To: T10 Technical Committee
From: Amr Wassal, PMC-Sierra (amr_wassal@pmc-sierra.com)
Date: 24 August 2006
Subject: 06-324r1 SAS-2 Modifications to the SAS Speed Negotiation

Suggested changes to chapter 6 (Phy Layer)

Figure 132 — SP (phy layer) state machine - SAS speed negotiation states (continued)

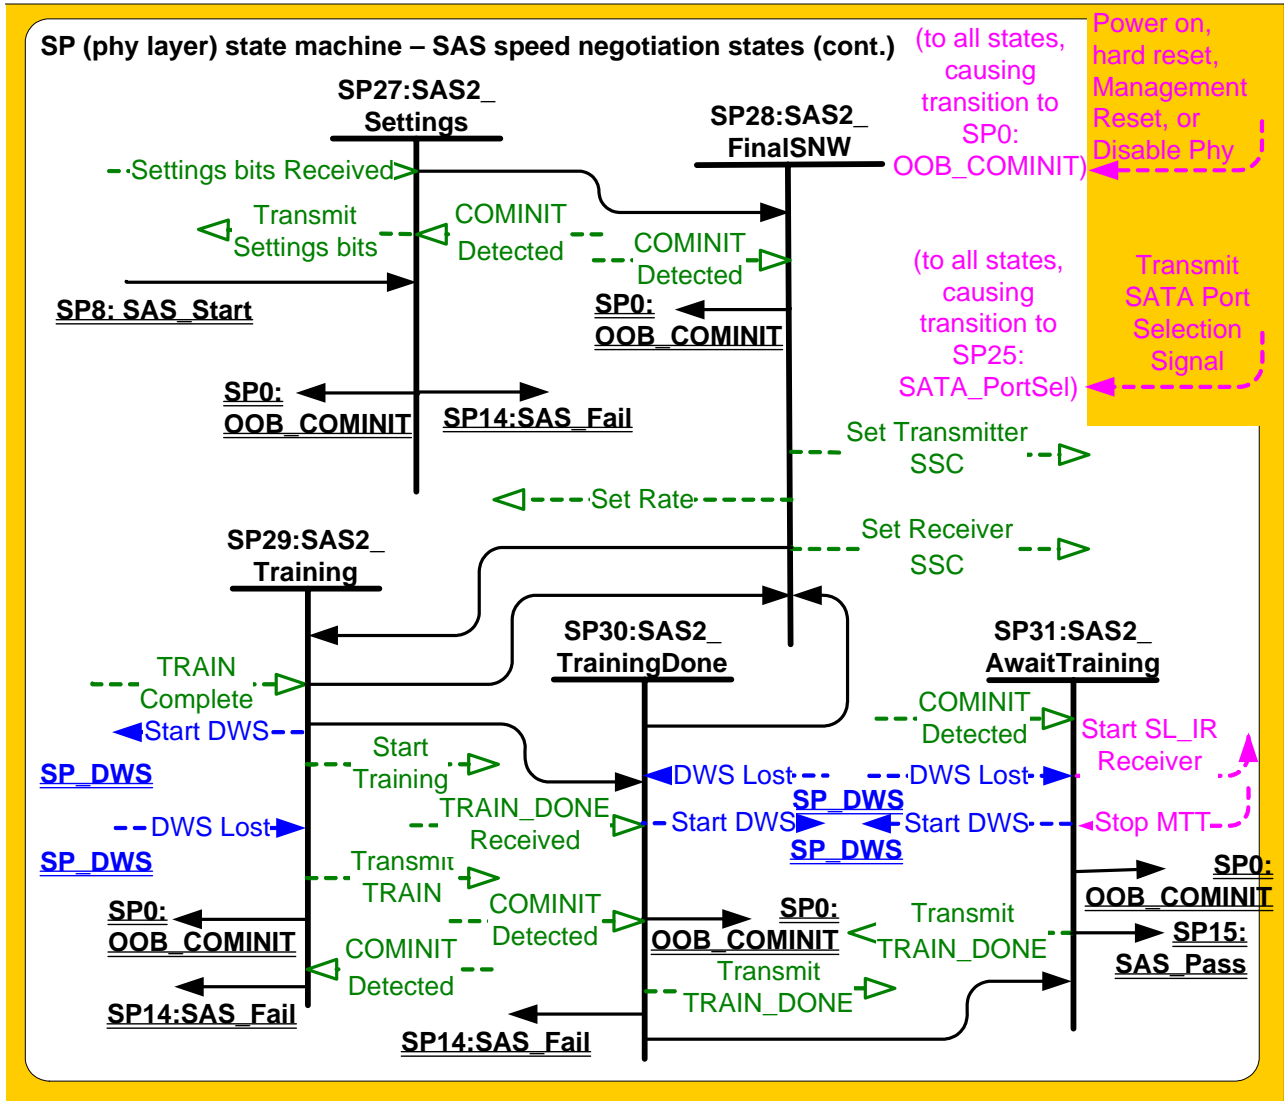
Figure 132 shows the rest of the SAS speed negotiation states related to SNW-3 and the SNW-Final speed negotiation windows. These states are indicated by state names with a prefix of SAS2.
